ECE/TRANS/WP.29/GRPE/2014/4

Retrofit Emission Control Devices (REC)

Updated Proposal for the 01 series of amendments to the UN Regulation on uniform provisions concerning the approval of Retrofit Emission Control devices for heavy duty vehicles

Submitted by the Chair of the informal working group on Retrofit Emission Control devices (REC)*

Arrangement of the REC ~~System~~ Type-Approval mark

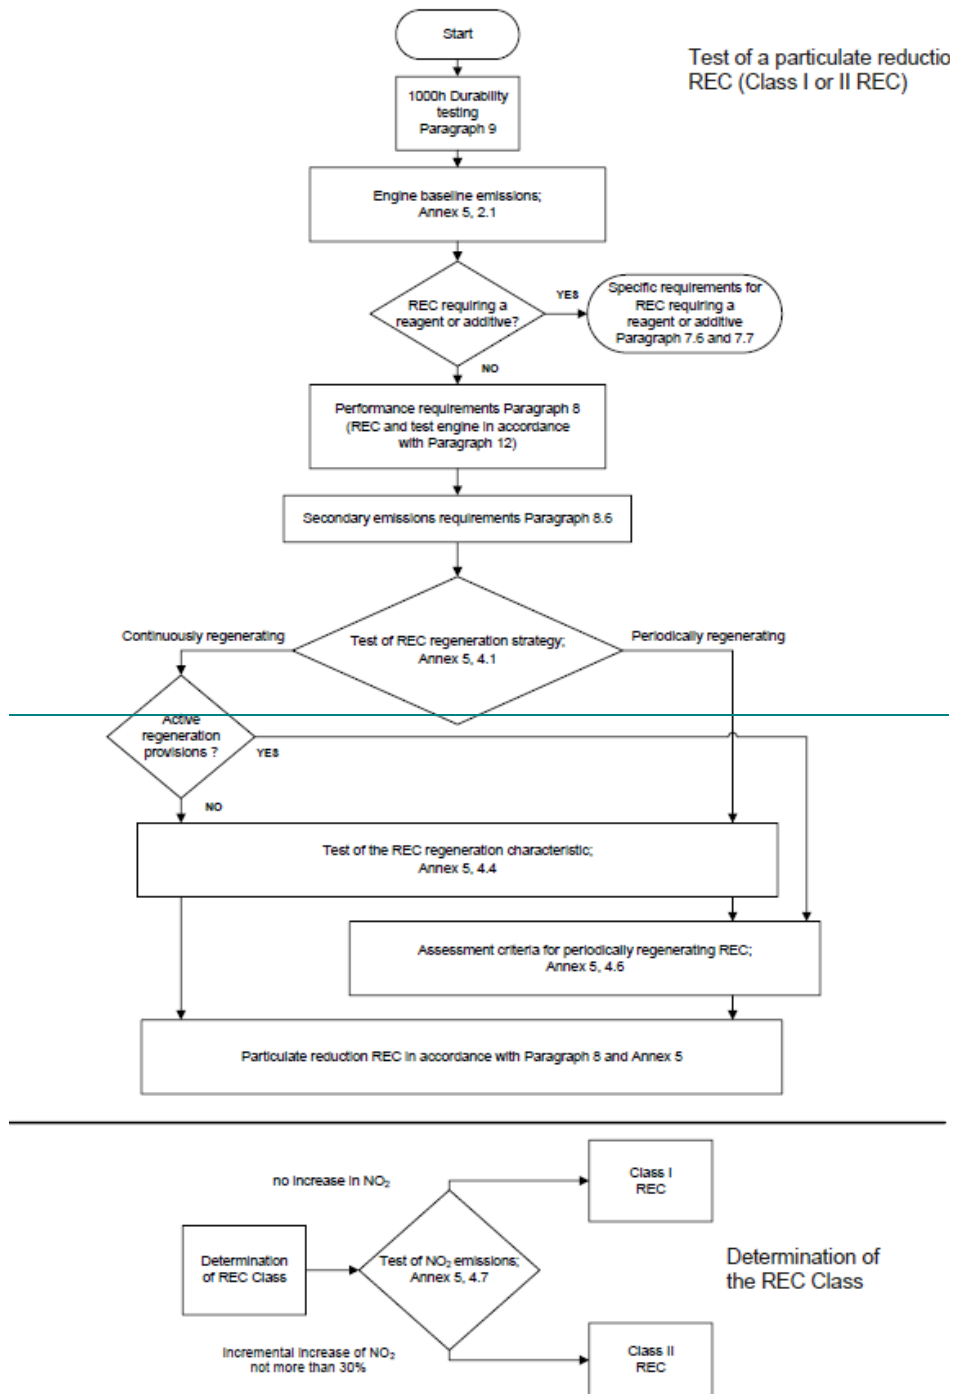
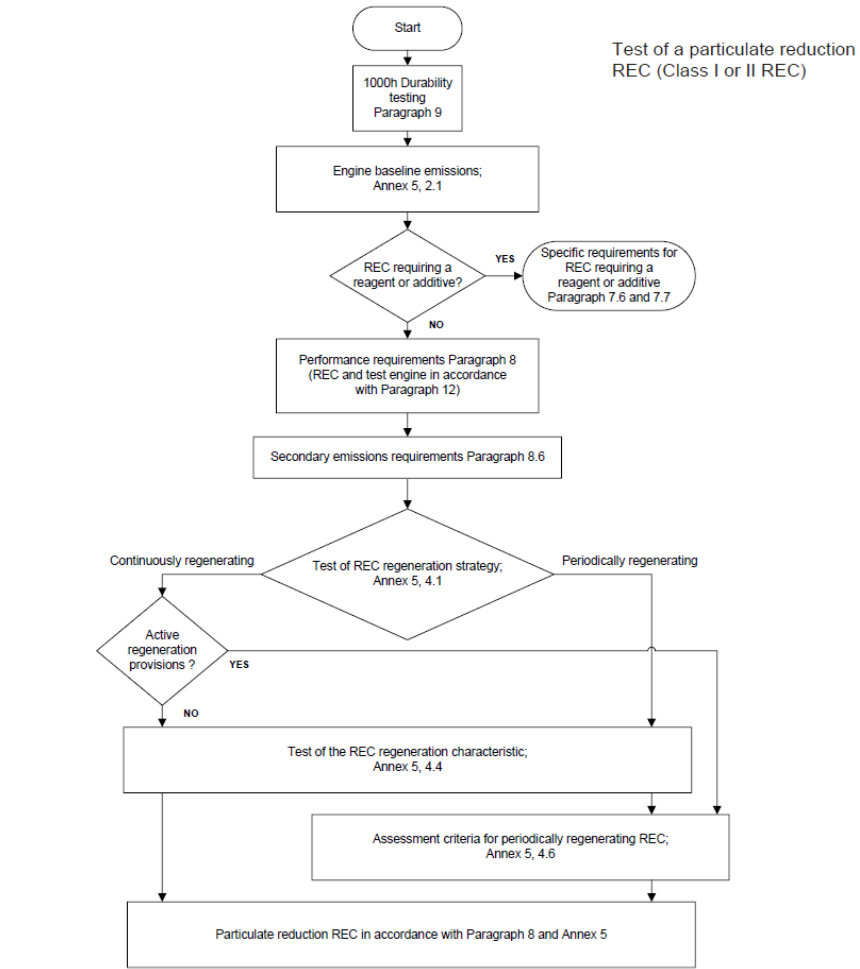
Annex 4, amend to read:

The above example type-approval mark affixed to a REC shows that the type concerned has been approved in the Netherlands (E4), pursuant to Regulation No. [nnn] under type-approval No. 001234. The first two digits of the type-approval number indicate that the approval was granted in accordance with the requirements of Regulation No. [nnn] in ~~its original~~ the form amended by this series. The approval mark shall also show the Class of REC (I, IIA, IIB, III or IV)."

Determination of the REC Class

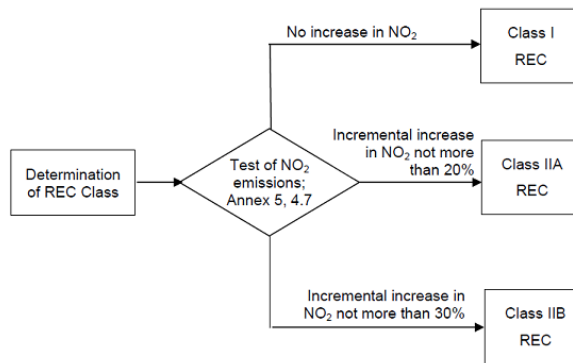
Annex 8, amend to read:

1. Test sequence for particulate reduction REC
